# NORTH BRANCH

**PLANNING COMMISSION  
REGULAR AGENDA  
TUESDAY, JULY 1, 2025 @ 6:30 PM  
CITY HALL, 6408 ELM STREET, NORTH  
BRANCH, MN 55056**

MAIN STREET APARTMENTS  
 OWNER: TOMMY FOSTER  
 1275 WEST 4TH ST, RUSH CITY, MN

**LANDSCAPE AND TREE PRESERVATION PLAN**

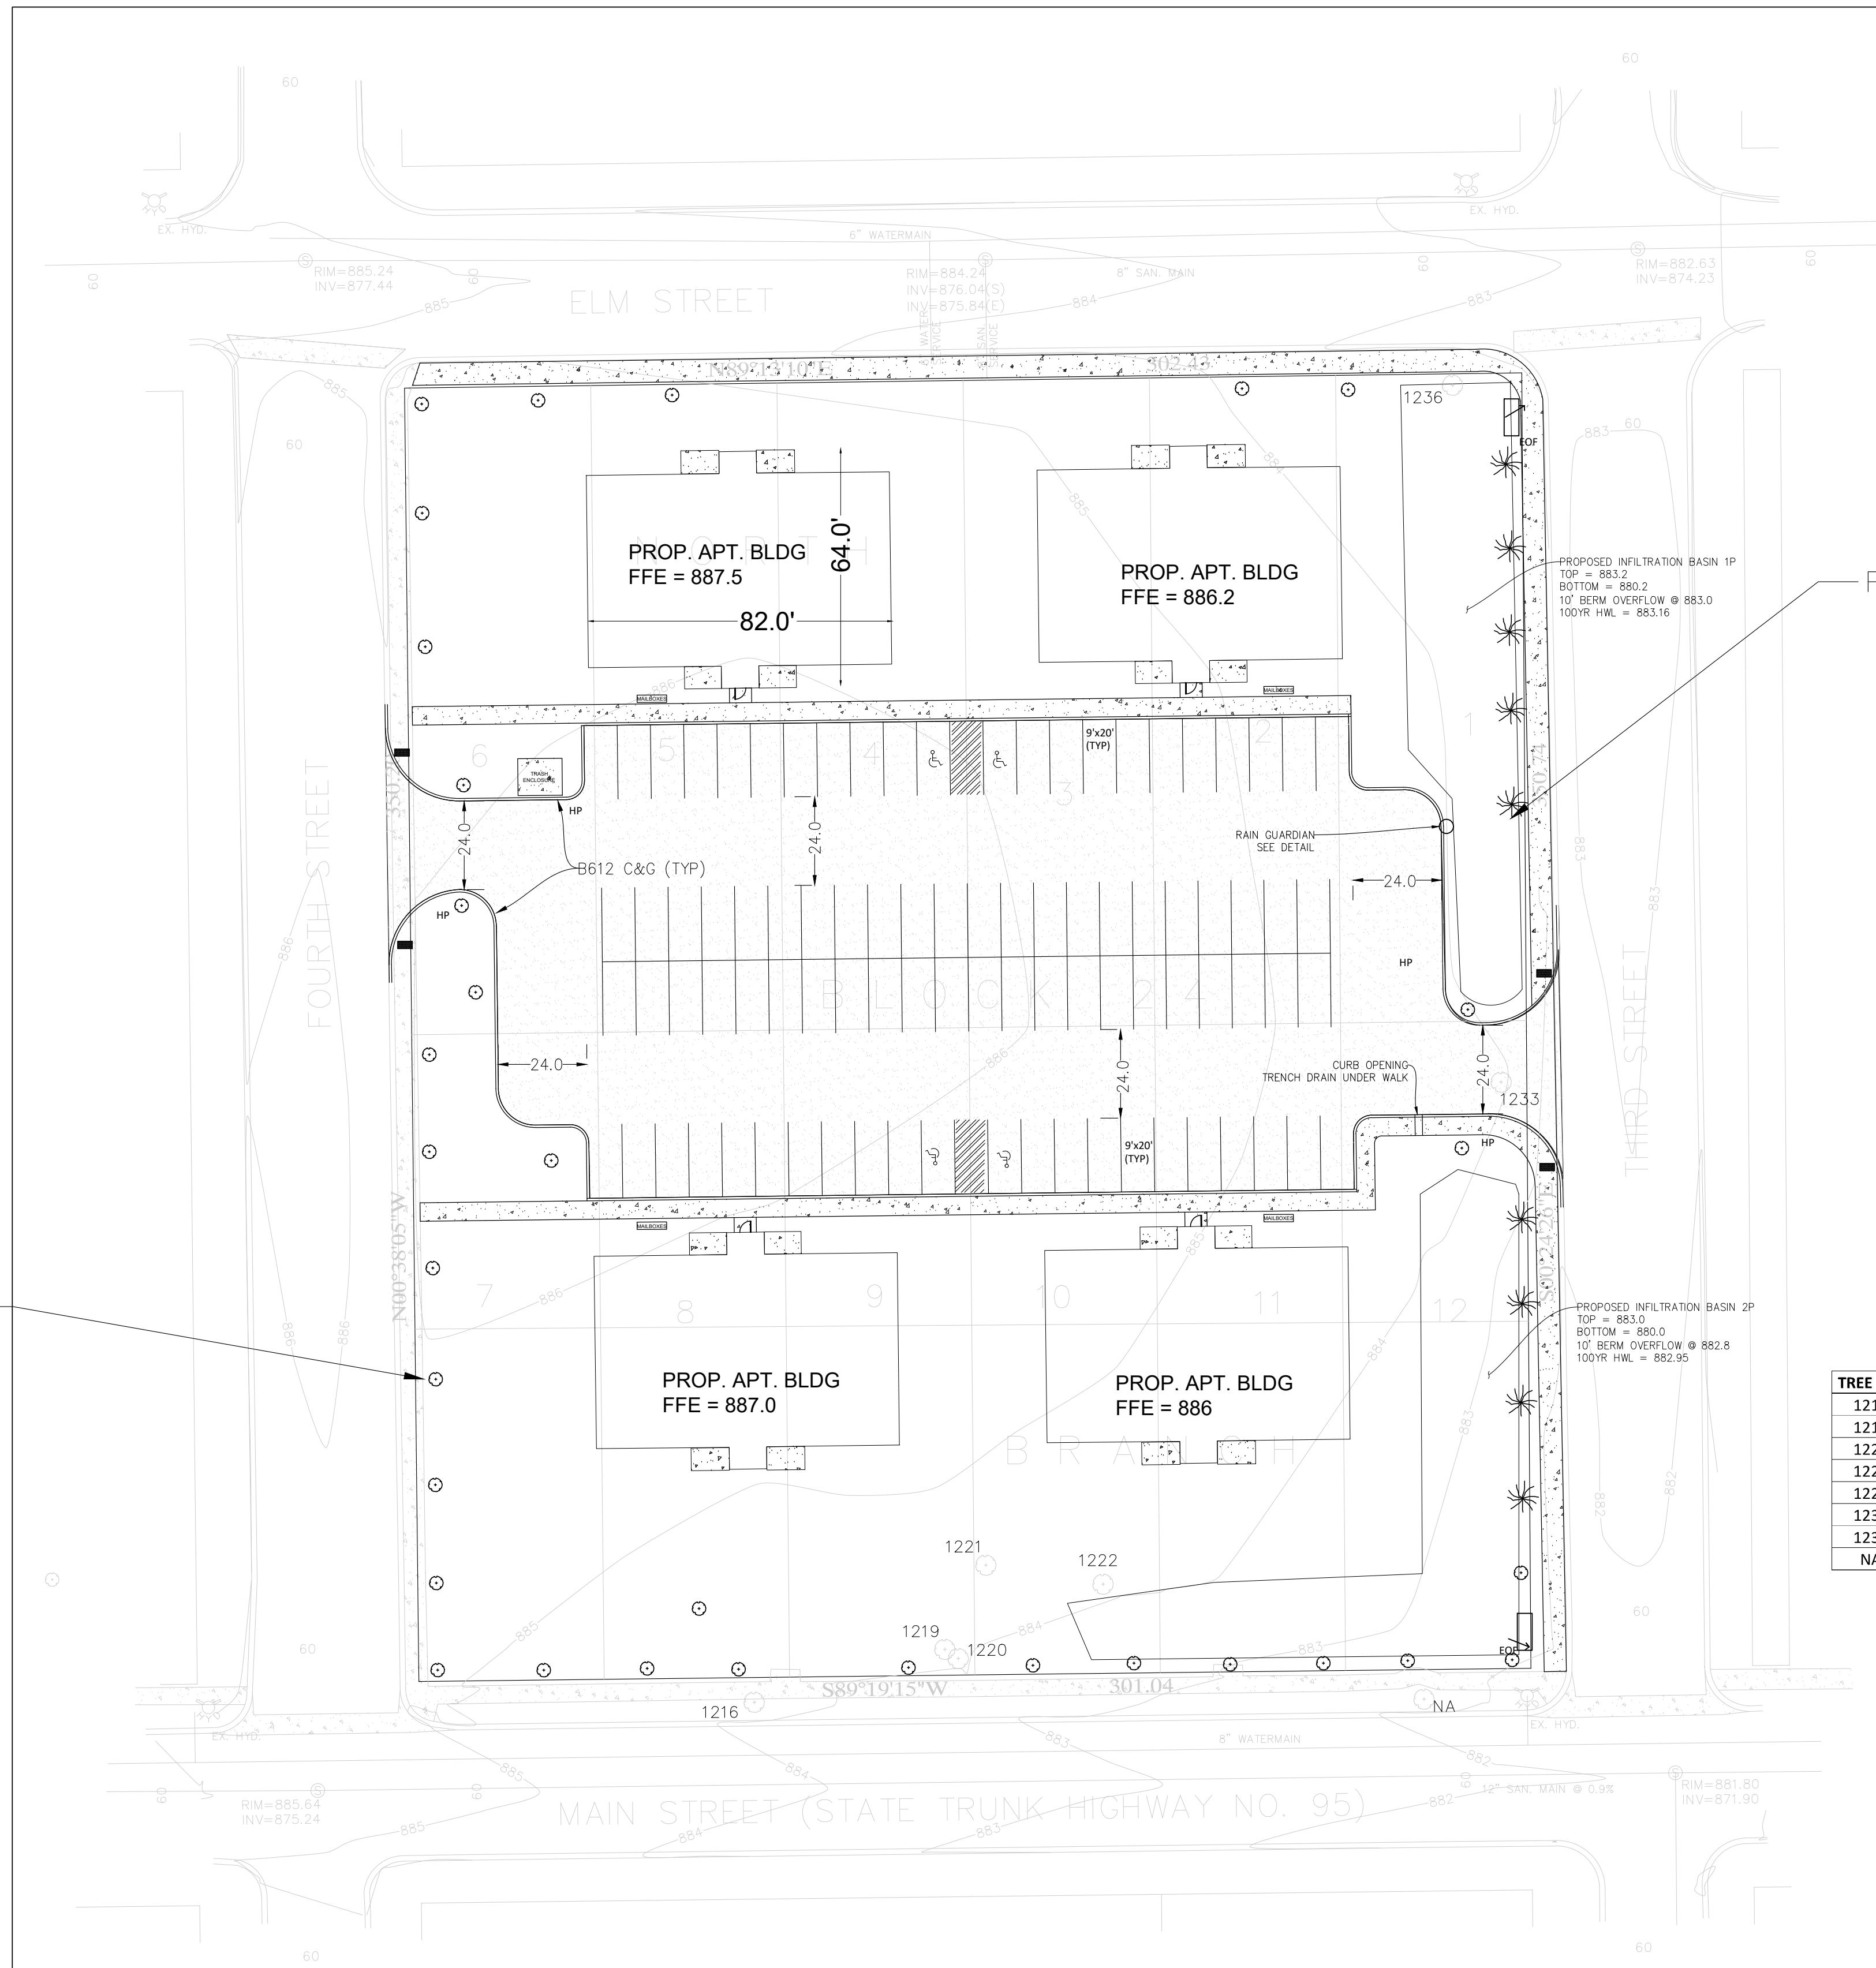
The tree preservation plan show the site contains 8 existing trees with 1 planned for removal. The site is a highly visible site in the downtown area and significant landscaping is desired for the site.

From a landscape perspective, the ordinance generally requires 1 tree per unit for multi-family development, which is what is proposed on the plan. The CBD district is not held to that

standard necessarily; and given the sites high visibility and lack of natural vegetation, staff is recommending additional landscaping above what is proposed by the applicant. The plan illustrates 32 overstory trees along the perimeter of the site, with 12 on the south side meaning a spacing of approximately 25'. The west side would be similar to the north side having 6 trees and the east having 3 due to the location of the drainage ponds. Based upon the notes on the landscape plan they all appear to be either red oak or white maples. The applicant should provide more vegetation over the entire site. There are no trees between buildings and nothing closer to any of the four structures. They do not show any landscaping around the buildings or a seed mix specifically for the drainage areas which could be vegetated more attractively than the present condition. This plan reflects the minimum expectation for plantings on the site and additional work is needed to elevate the site plan to be consistent with the goals of the comprehensive plan for the downtown.

The developer has provided a revised landscaping plan to address screening along the east side of the site. along with revised building and architectural plans to meet the city design standards.
